## Section 75W Modification

Lot 36 DP 1214499

Belle O'Connor Street, South West Rocks

Project Approval 08\_0167 (Malbec SWR P/L)

Illustration 2.2      Northern APZ:

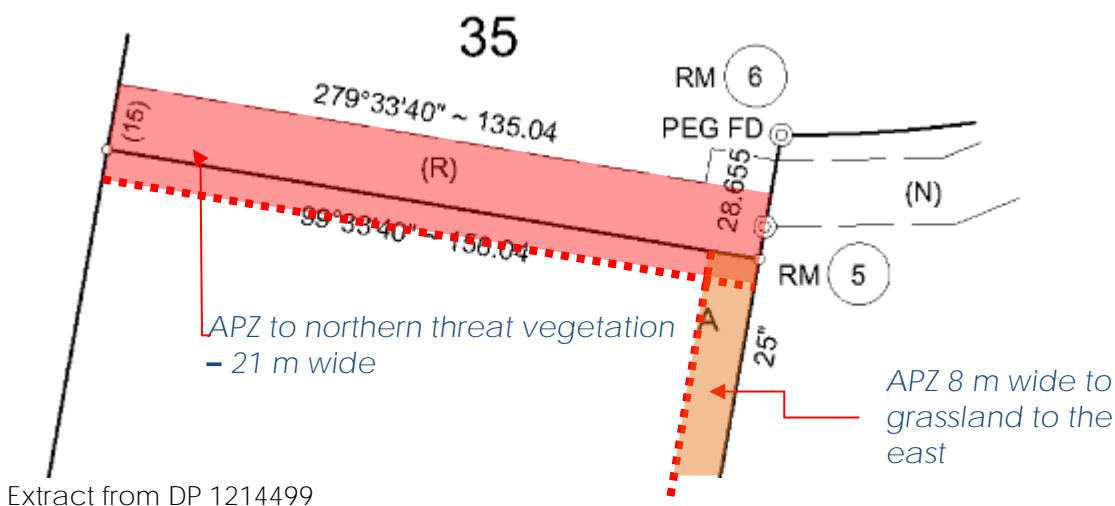
The amended layout enables the provision of required Asset Protection Zones for future residential buildings within the proposed development area. The northern APZ will occupy the existing Easement to Drain Water 15 m wide and variable (located within Lot 35 DP 1214499) and 6 m along the northern boundary of proposed Lots 3 to 19, as shown below:

There is no requirement for an APZ to the golf course to the west of the site or from the vacant land in the southwestern corner of the site. This differs from APZ shown on the approved plans (Sheet 1 of 3 of Project Approval MP\_08\_0167MOD1). The Bushfire Risk Assessment carried out by FLoraFauna Consulting is considered to accurately represent site and vegetation conditions. It is therefore requested that the APZs shown at Illustration 2.2 are adopted for this modification. The approved APZs are shown at Illustration 2.3.
